A G E N D A

SPECIAL MEETING OF THE PLAN COMMISSION OF THE VILLAGE OF WILLOWBROOK TO BE HELD ON WEDNESDAY, AUGUST 26, 2015 AT 7:00 P.M. AT THE VILLAGE POLICE STATION BUILDING, 7760 QUINCY STREET, IN THE VILLAGE OF WILLOWBROOK, DUPAGE COUNTY, ILLINOIS

Case Title: PC 15-04: 7850 Quincy, Willowbrook Baseball/Softball Facility

Meeting Date: August 26, 2015
Prepared By: Jo Ellen Charlton, Planning Consultant
Case Title: Final Plat of 7523 Brookbank Subdivision
Petitioner: Cole Court LLC.
John Barcelona, President
485 S. Frontage Road – Suite 100
Burr Ridge, IL 60527
Action Requested by Applicant: Approval of a 2 lot Final Plat of Subdivision

3 Handicap Spaces
Moving to west

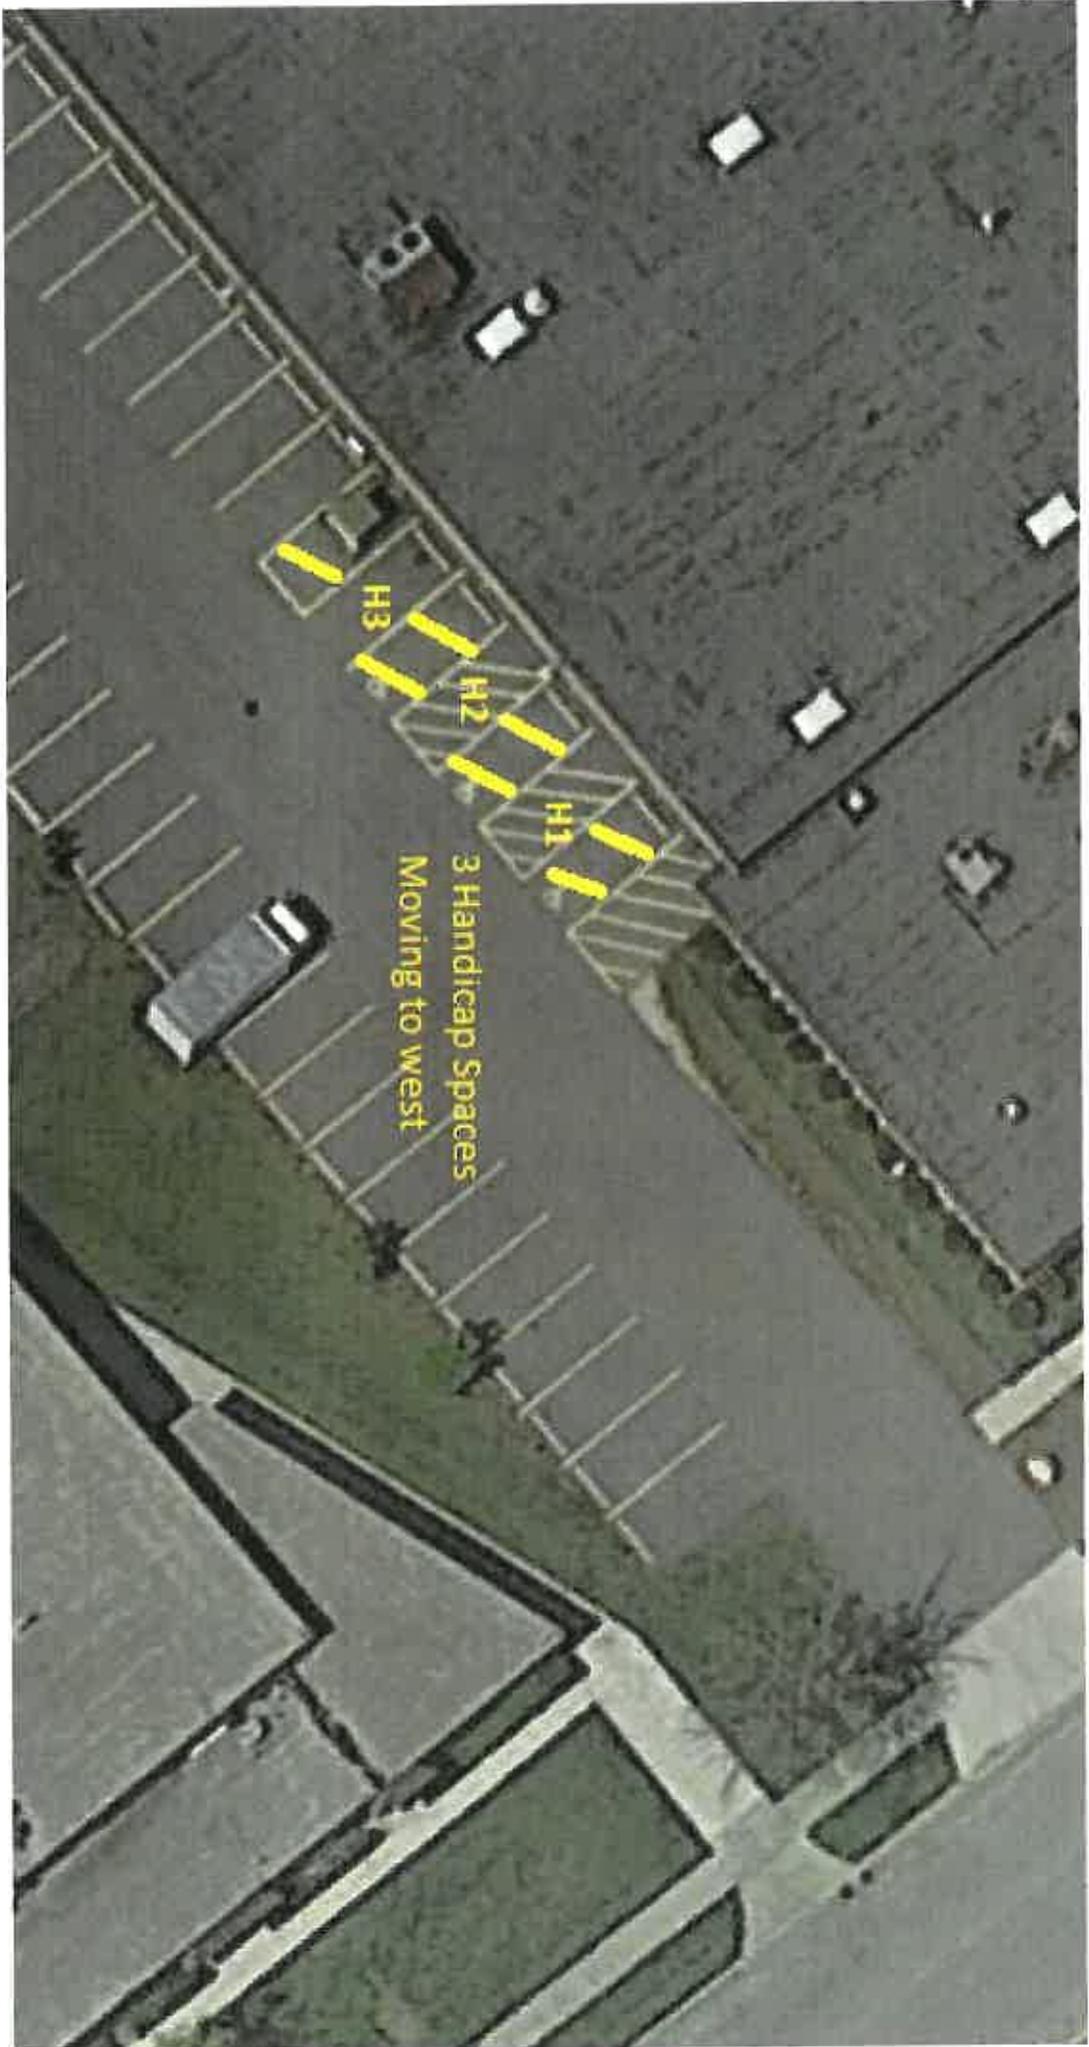
adjoining accessible parking space, which is not allowed pursuant to State law. Staff originally asked that a raised curbed sidewalk area be added in this location to separate the entrance from the driving surface and provide a safer entrance area for young students to utilize. Given the elevation of the floor in this location, however, the grade cannot be raised with a sidewalk, so the applicant will be adding protective bollards around the area to make the area more secure from cars. This concept is shown on one of the pages in Exhibit 2. This will also require the restriping of the accessible parking spaces immediately west of this door, which is also shown in Exhibit 2.

- b. Details and installation of protective bollards around the proposed south entrance door.**
 - c. Restriping and signage details for the accessible parking spaces west of the new entrance door.**

EXISTING CONDITIONS & DEMOLITION PLAN

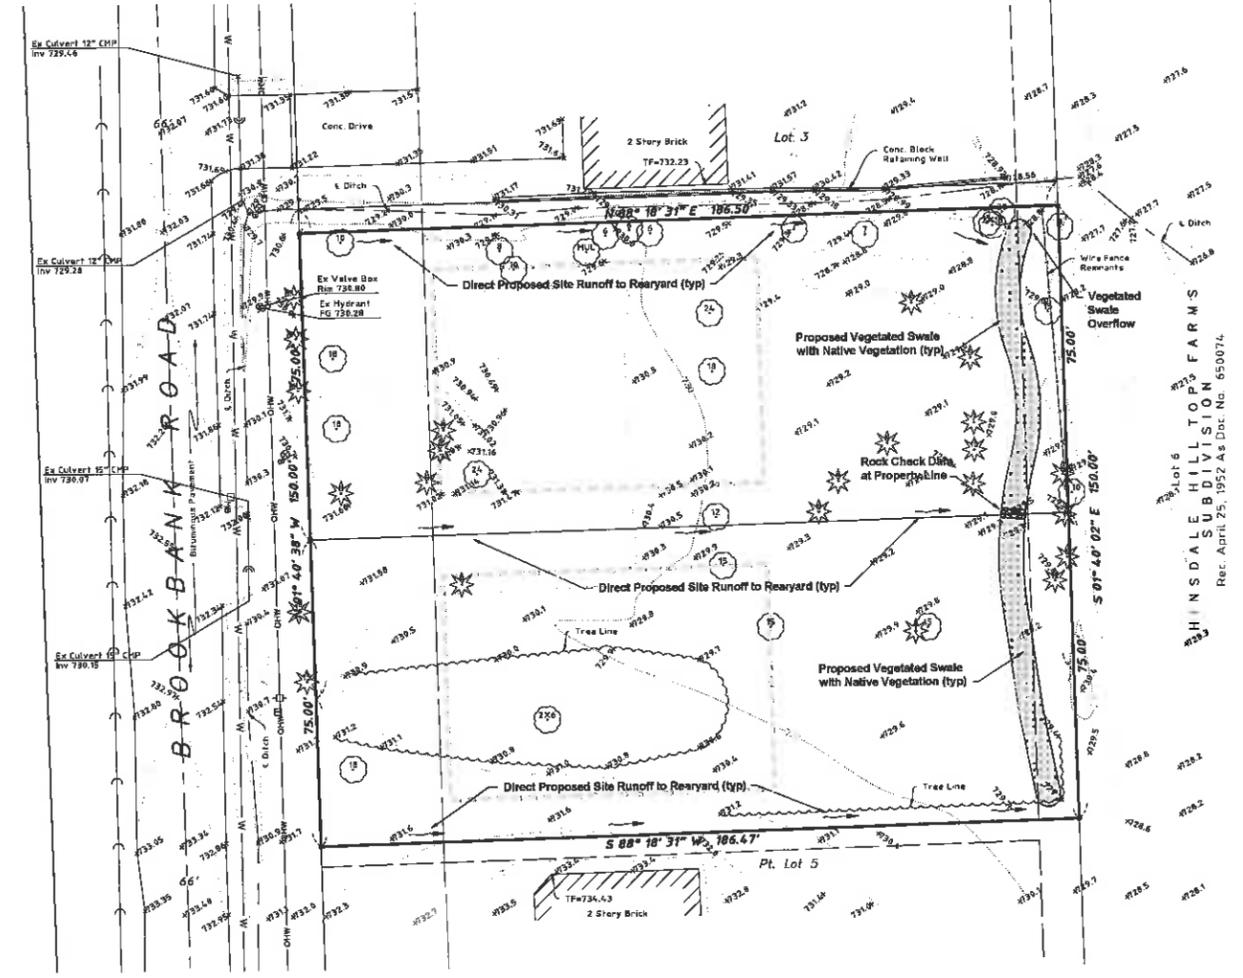
1. The proposed PCBMPs shown are presumed to be conceptual as the final design cannot be completed until a specific site plan is developed for each lot. It would be prudent, though, to identify the existing impervious cover for each lot and an indication of how that will be applied to the proposed lot development (e.g. all existing impervious surface to first lot developed, split evenly of both lot, or based on the lot on which it is situated).

Exhibit 1

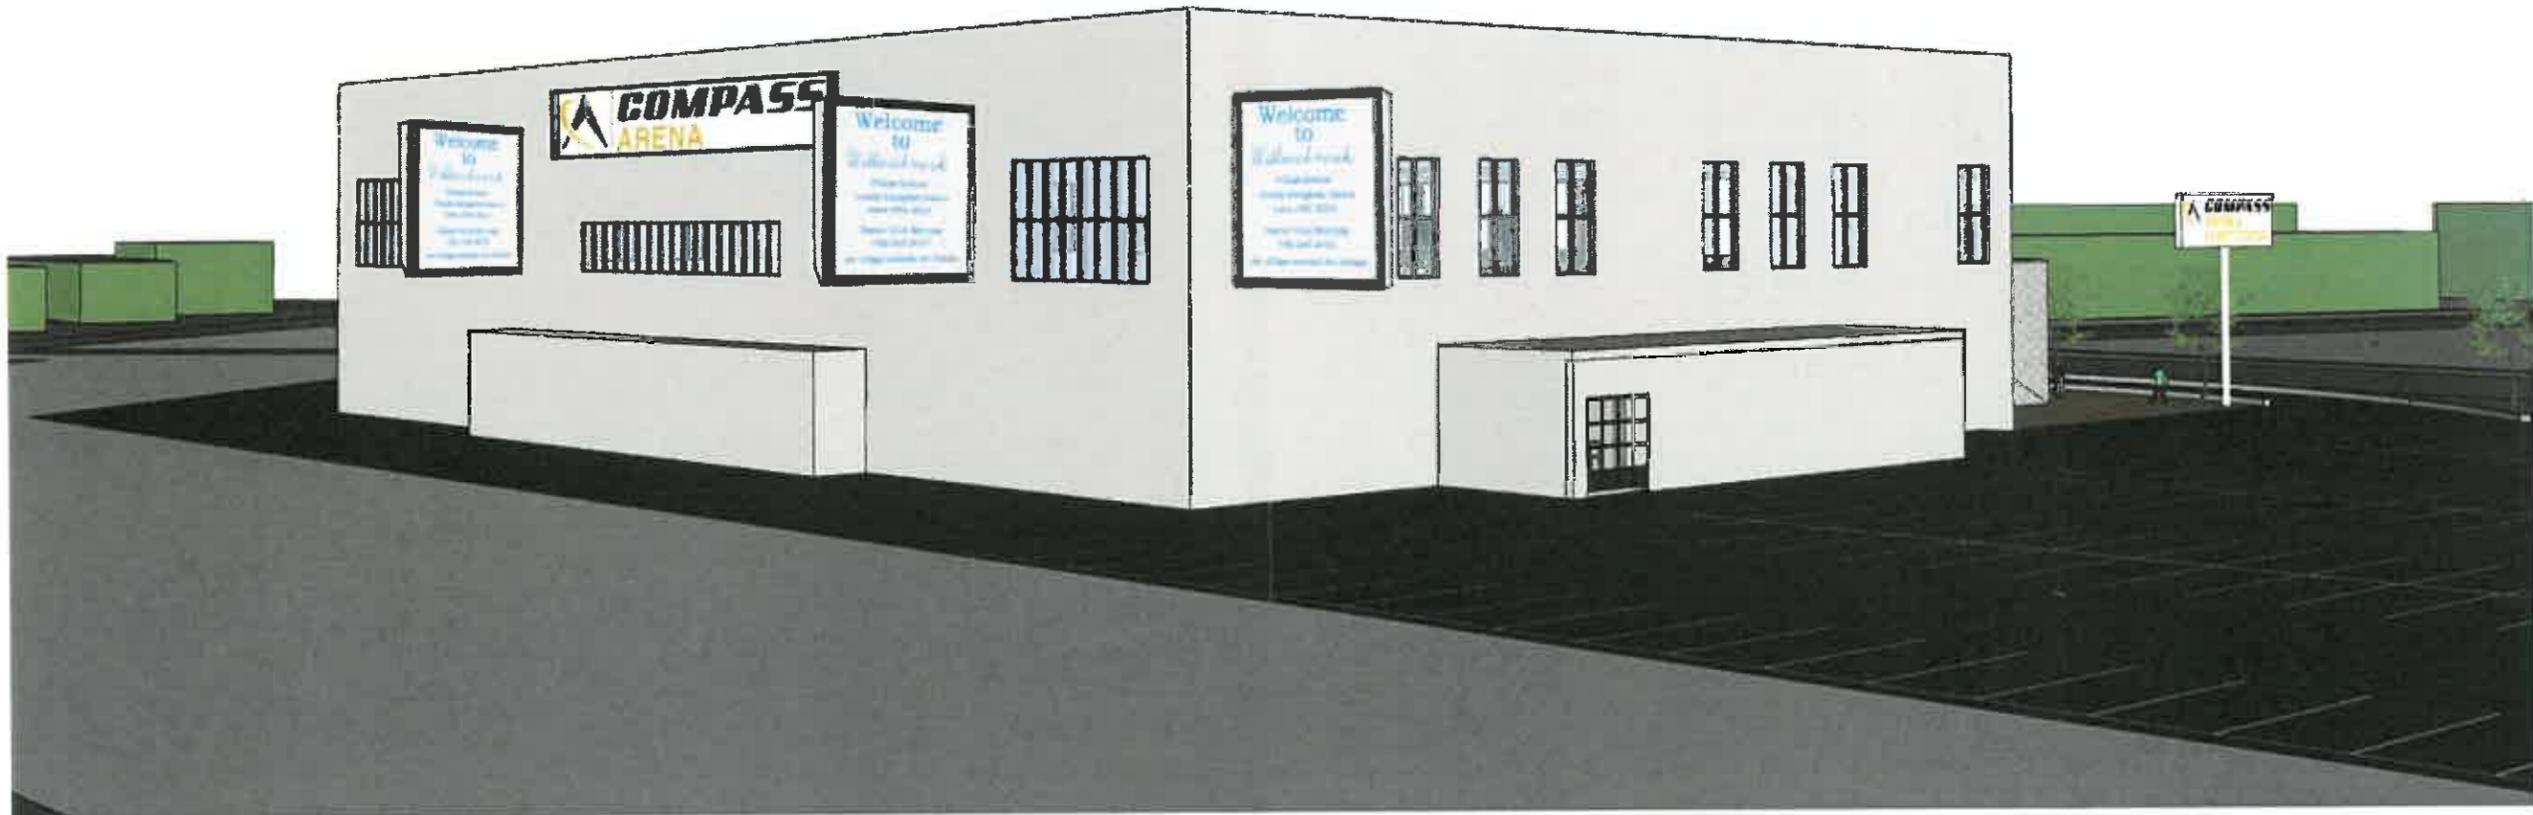
Included in the application was a rough elevation drawing that I believe is a view of the building from the northeast, looking southwest...or what you might see if you were heading south on I-55. Note that the three (3) signs that show “Welcome to Willowbrook” are each intended to be 2-sided, projecting, v-shaped digital signs, for a total of 6 individual sign faces, plus the Compass wall sign. Per staff’s follow up request for dimensions, the applicant confirmed via a written e-mail that the two similar signs on the south elevation (which parallels I-55) are 18’x22’ or 396 square feet, or 1,584 square feet for the four (4) sign faces. The Compass wall sign is reported to be 12’ x 51’ or 612. The east elevation digital sign is apparently slightly smaller at 17’x20’, or 340 square feet or 680 for its two (2) sign faces. Total square footage on these south and east elevations is 2,876 square feet, or over 600 percent larger than allowed by ordinance. Additionally, previous plans showed additional wall signs on other elevations, although they were not provided with this submittal.

The Plan Commission previously advised the applicant there would be no support for these digital signs along the expressway. Furthermore, staff has confirmed with the Illinois Department of Transportation that these types of signs are no longer permitted given the corridor’s designation as

Staff encourages the Plan Commission to reiterate its previous direction to the applicant that digital displays of any kind will not be permitted as wall signs on any of the building elevations. Instead, the applicant should be advised to provide elevation drawings to scale, showing all proposed wall signs, and include dimensions. If the Compass wall sign on the southern elevation is indeed 12' as indicated in the subsequent e-mail, the height of the building in that area is over 72' tall, which would be the tallest commercial building in town...although I'm guessing the building isn't really intended to be that tall and that either the scaling is off in the elevation drawing or the sign dimensions provided in the e-mail are wrong. Staff has advised the applicant that as a PUD, reasonable exceptions to allow for more square footage might be considered for wall signage that incorporates good design and "fits" with the overall product. The provision of these requested scaled and dimensioned elevation drawings will help staff and the Plan Commission evaluate such a request.

1. Provide a sign package for staff review that is complete and to scale that does not include digital wall signs. Reasonable digital signage may be considered on the monument sign if it is otherwise constructed pursuant to code and sensitive to its relationship with the Chicken Basket sign.
2. Eliminate uses and their associated square footages until parking can be accommodated at grade (may exclude everything above the first floor);

THIRD FLOOR PLAN
1/8" = 1'-0"

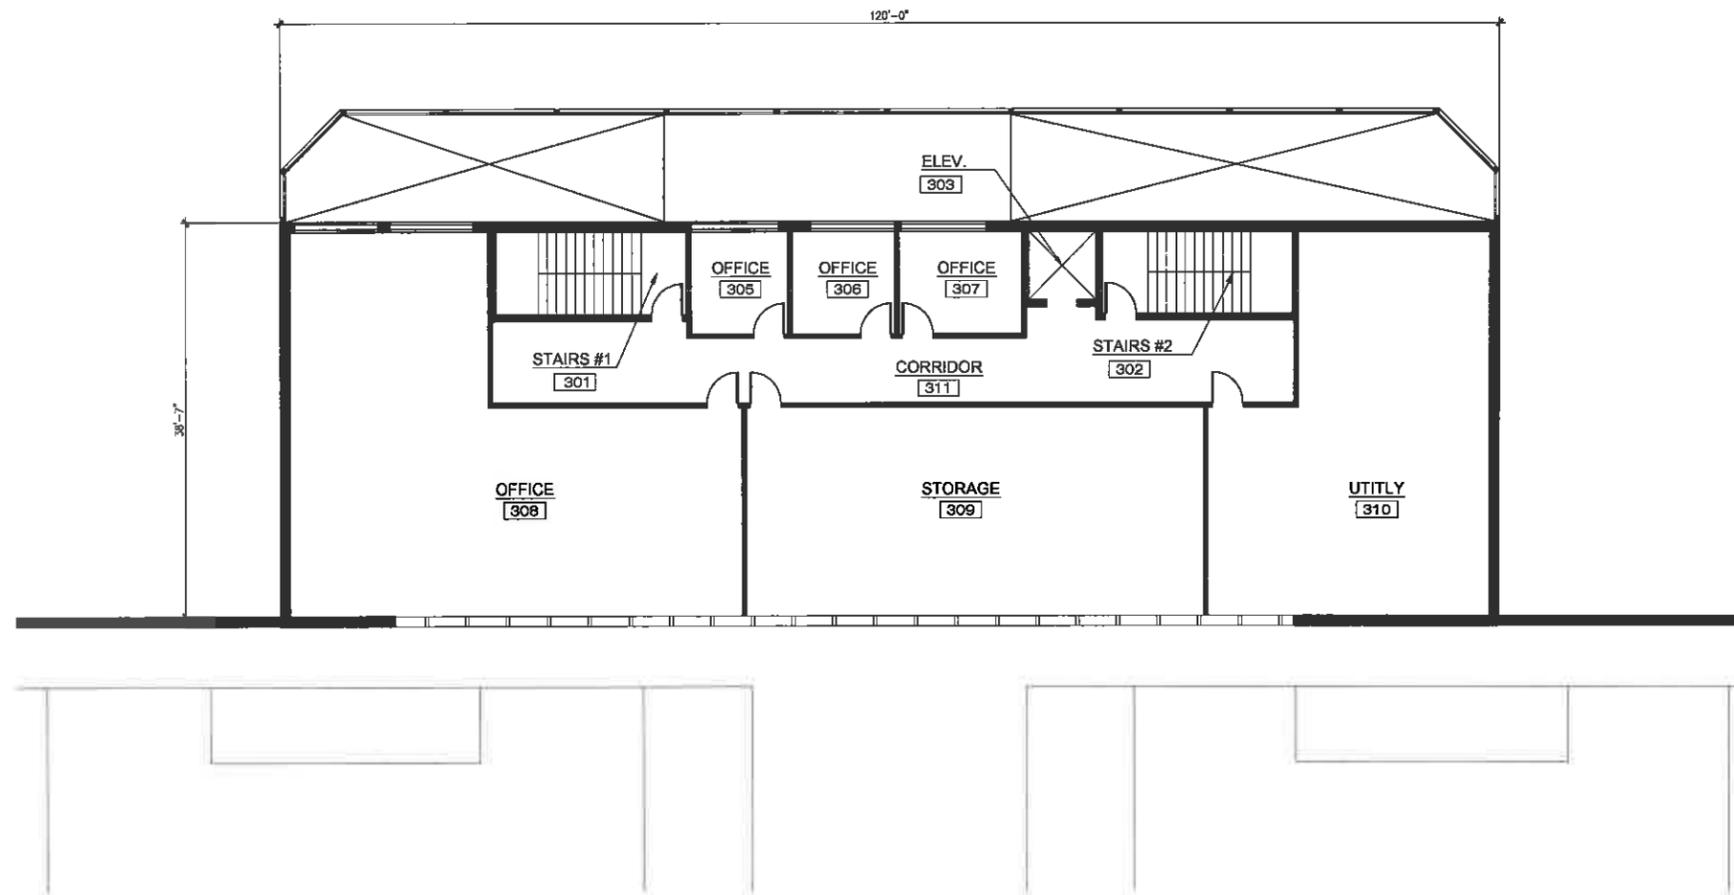
3rd Floor: 4,955 square feet of office, “storage” and “utility” space. This was the space that was previously designated for additional bar and party space, including a cigar lounge. This floor had been removed from the plans to better address parking until this most recent submittal.
